**S-4889**  
**TIMBERBROOK MEADOWS SUBDIVISION, PHASE 1**  
**(major-preliminary)**

**STAFF REPORT**  
**January 9, 2020**

**TIMBERBROOK MEADOWS SUBDIVISION PHASE 1**  
**Major-Preliminary Plat**

**Staff Report**  
**January 9, 2020**

MARK	DATE	DESCRIPTION
PROJECT NO:	18095	
FILE:	18095-SURVEY PP-PH1.DWG	
DRAWN BY:	DLP	
CHECKED BY:	JRF	
LOCATION:	A PART OF THE NORTHEAST QUARTER OF SECTION 25, TOWNSHIP 24 NORTH, RANGE 5 WEST, WABASH TOWNSHIP, TIPPECANOE COUNTY, INDIANA.	
TITLE:	<b>PRELIMINARY PLAT</b>	
	<b>OVERALL</b>	
	<b>1</b>

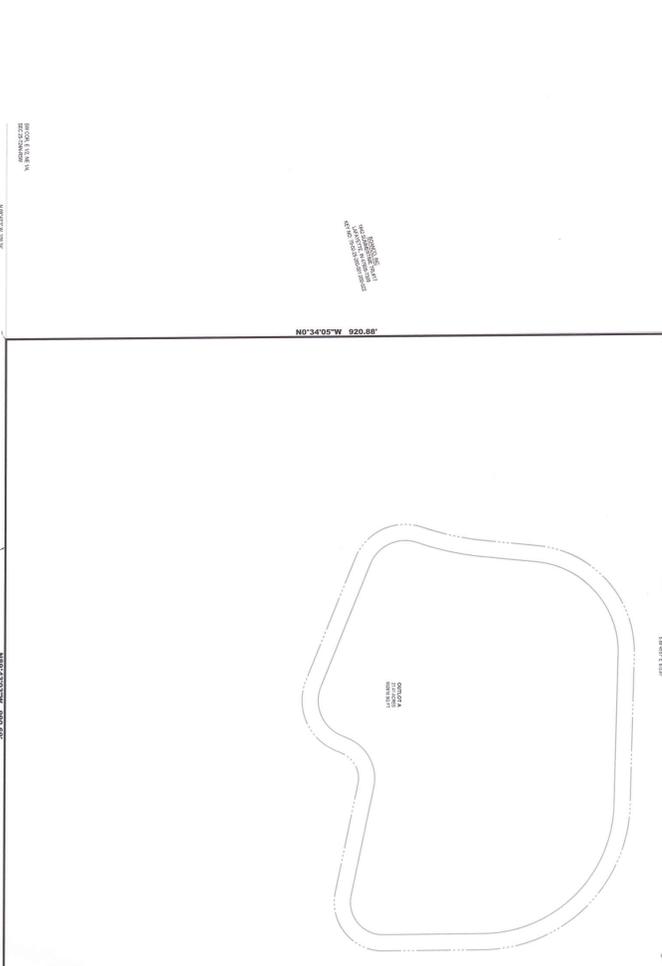
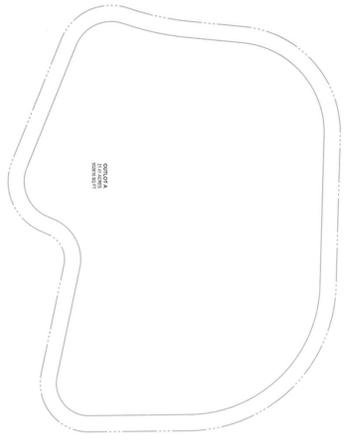
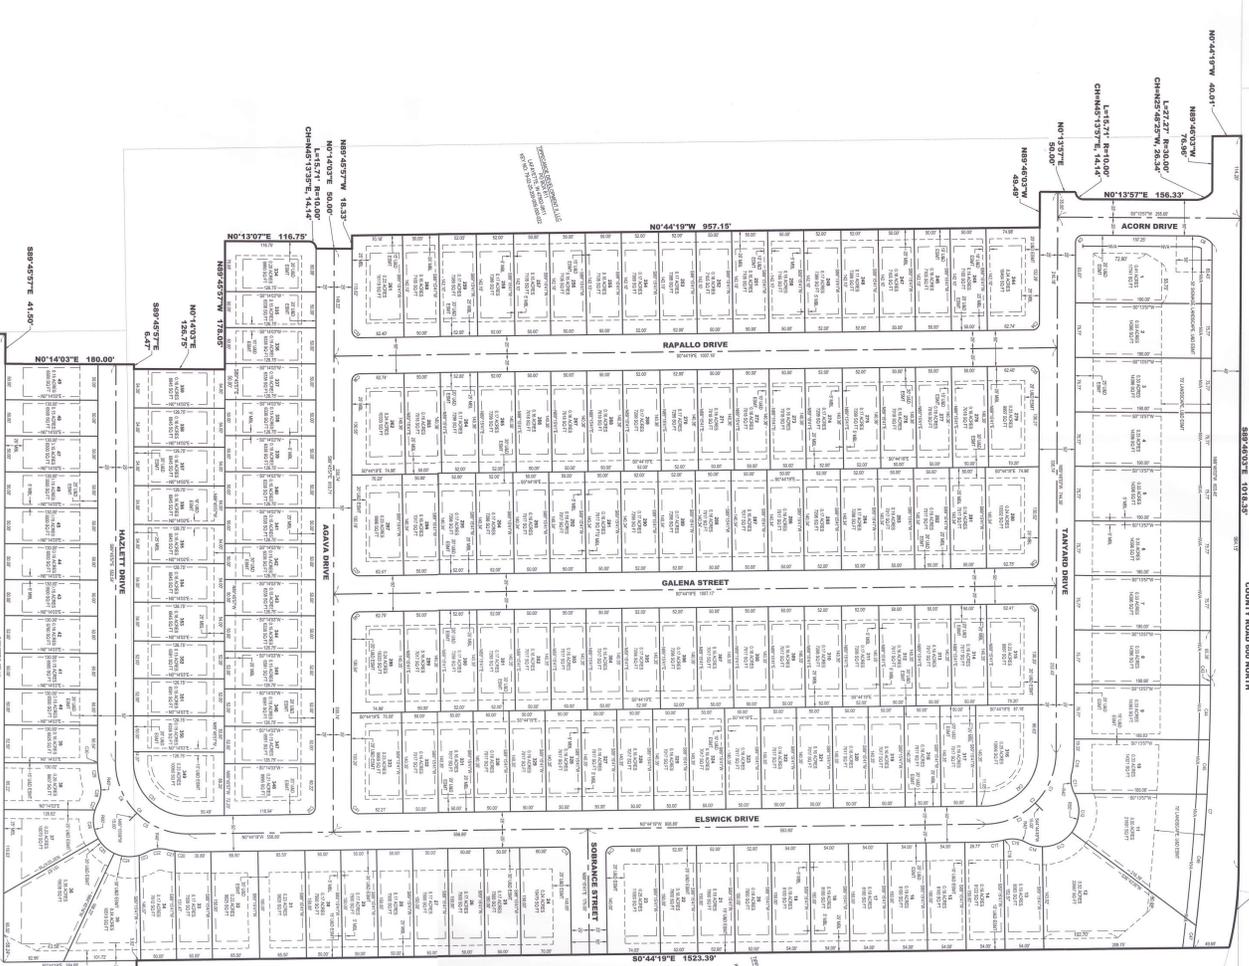
The rezoning of the overall 145 acres to R1B included a commitment to design the northern and western perimeter lots to the larger R1 zoning standards. As required by the commitment, this includes proposed Lots 1 through 12 of Phase 1. To comply with the commitment, the side setbacks for Lots 1 – 12 will need to be platted at the R-1 standard of 6-ft (as opposed to the note that says all side setbacks are 5-ft). All other lots meet and/or exceed the lot width, area and setbacks for R1B zoning.

Along with the larger R1 sized lots fronting CR 600 N, the preliminary plat shows a significant 70-ft wide landscaped berm along the rear yards of these lots.

7. As shown on the preliminary plat, the "No Vehicular Access" statement shall be platted along the CR 600 N right-of-way line and the Acorn Drive east right-of-way line.

10. Gateway signs, if any, shall be placed in an appropriate easement at the entrance(s).
11. All required building setbacks shall be platted.
12. The Regulatory Flood Elevation and Boundary for any Flood Plain in Outlot A shall be shown. It shall also be described and certified as specified in Unified Zoning Ordinance, Section 2-27-17.
